Product Change Notice

New dice replacement for Surface Mount Display

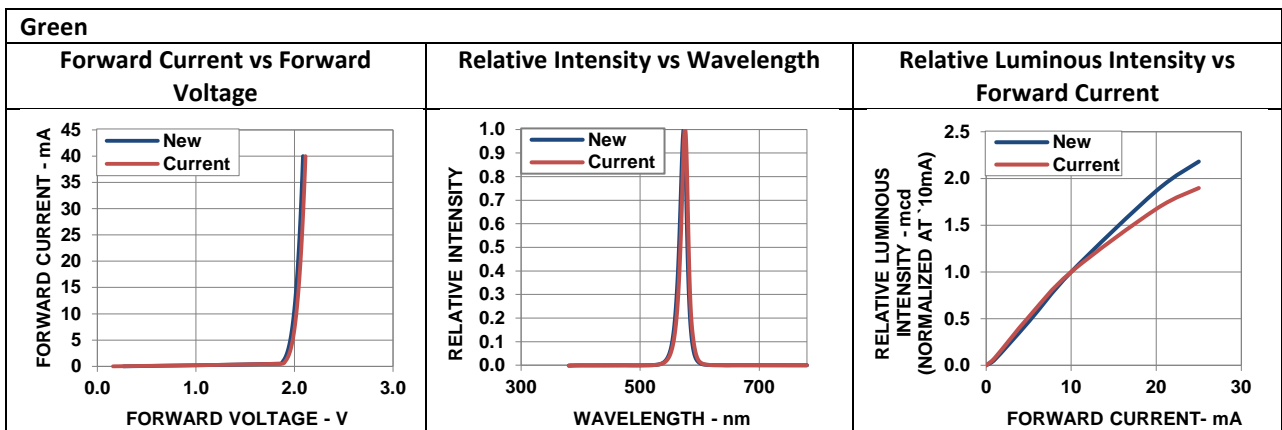
The new dice will replace the current dice for all affected part numbers.

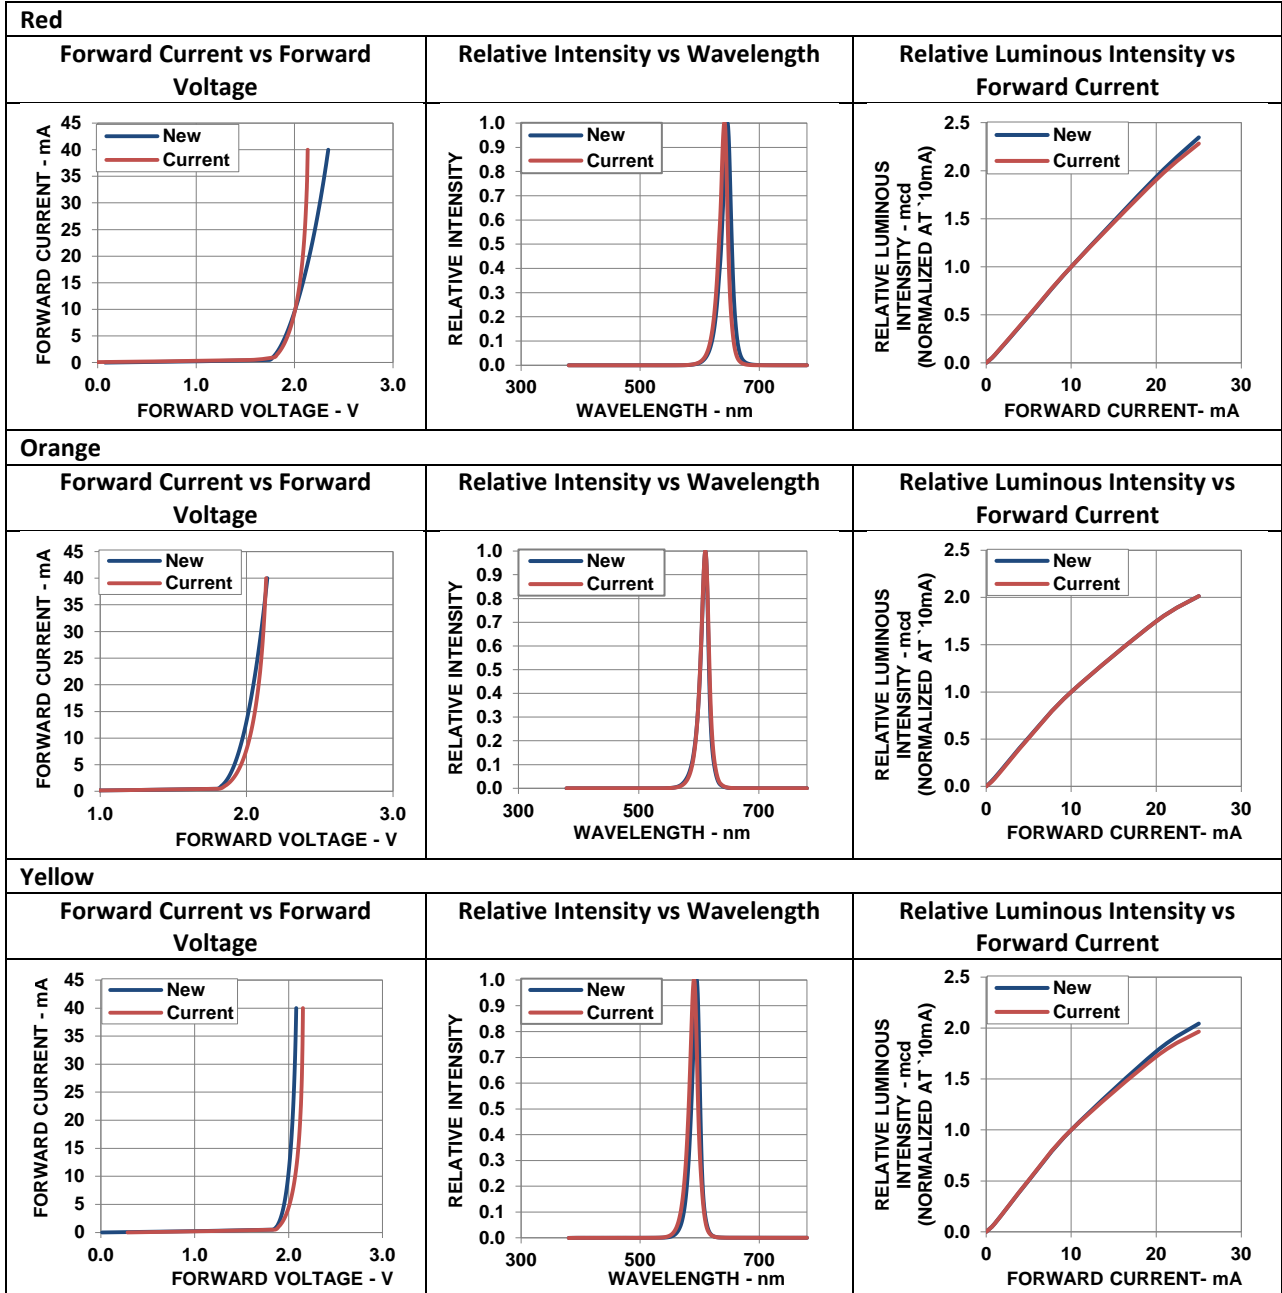
Following are changes in product characteristic:

1. Forward Voltage vs Forward Current
2. Relative Intensity vs Wavelength
3. Relative Intensity vs Forward Current
